**CITY OF NEWPORT BEACH
PLANNING COMMISSION STAFF REPORT**

SUBJECT: Mariner's Pointe - (PA2010-114)
100 – 300 West Coast Highway

- Architectural and Landscape Review
- Substantial Conformance Review

MARINER'S POINTE

West and East Elevations

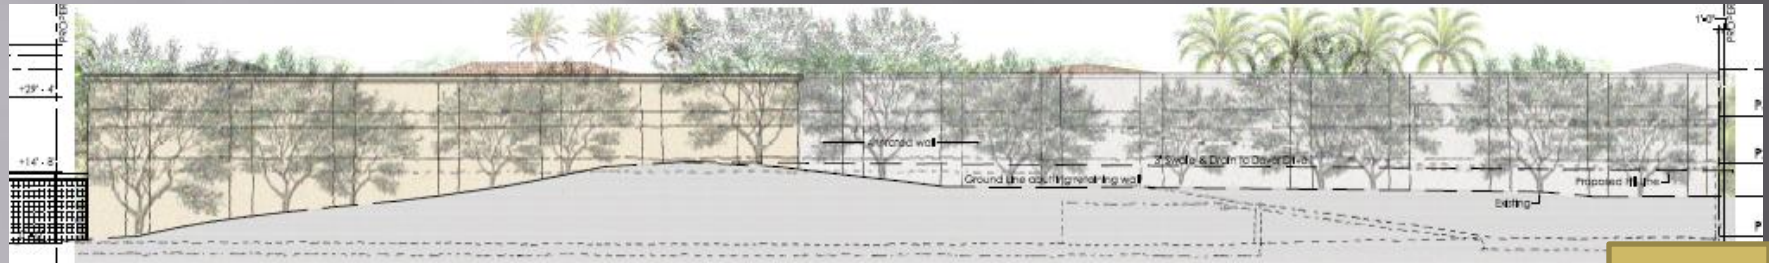
37'

40'

38'3"

North Elevation

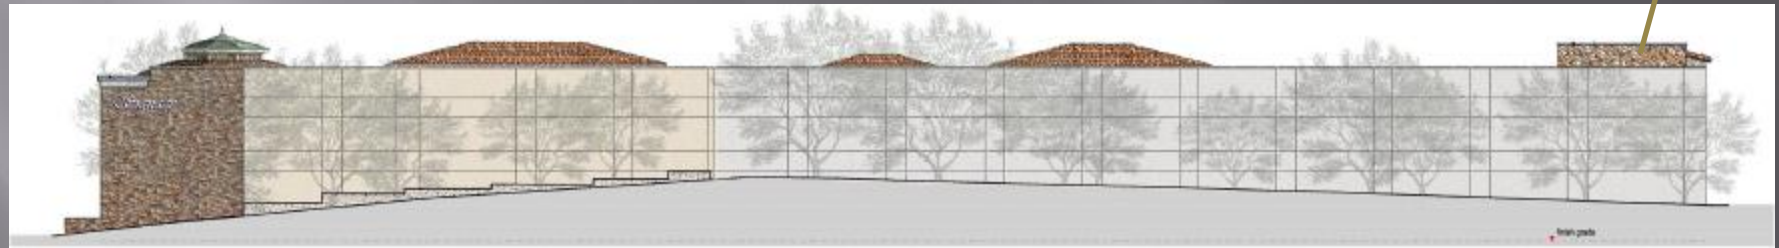
40'
